Access Compliance Report

Public Rights-of-Way

(Curb Ramps)

Intersection ID: 9521	Main Street: LAKEVIEW_ST	Cross Street: NORWOOD_DR	Location: S
ADA ID: 71295B29D3E7	Ramp Type: BlendTrans1	Initial Pass/Fail: Fail	Overall Compliance: No
Severity Score: 8.75			
Codes/Mitigation Info/Possible Solution		Field Measurements/Component Compliance

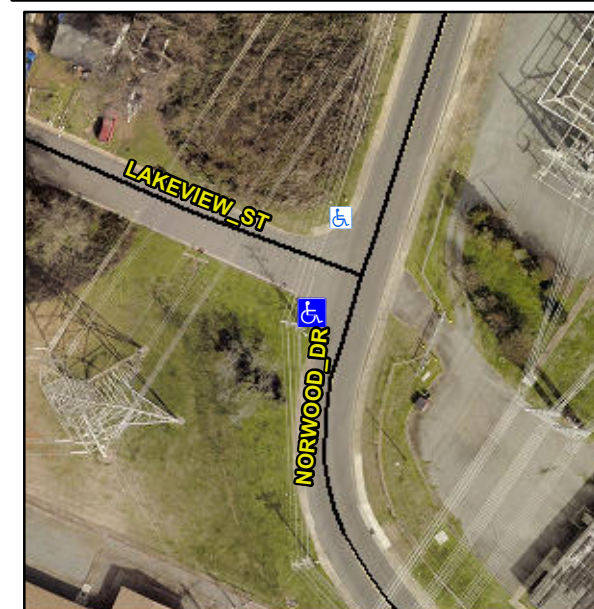
Surveyor Notes:

NO RT SW

PROW/ADA:

Not Found, R304.5.1

Possible Solutions:

Remove & Replace Curb Ramp With Two New Directional Ramps or Equivalent.
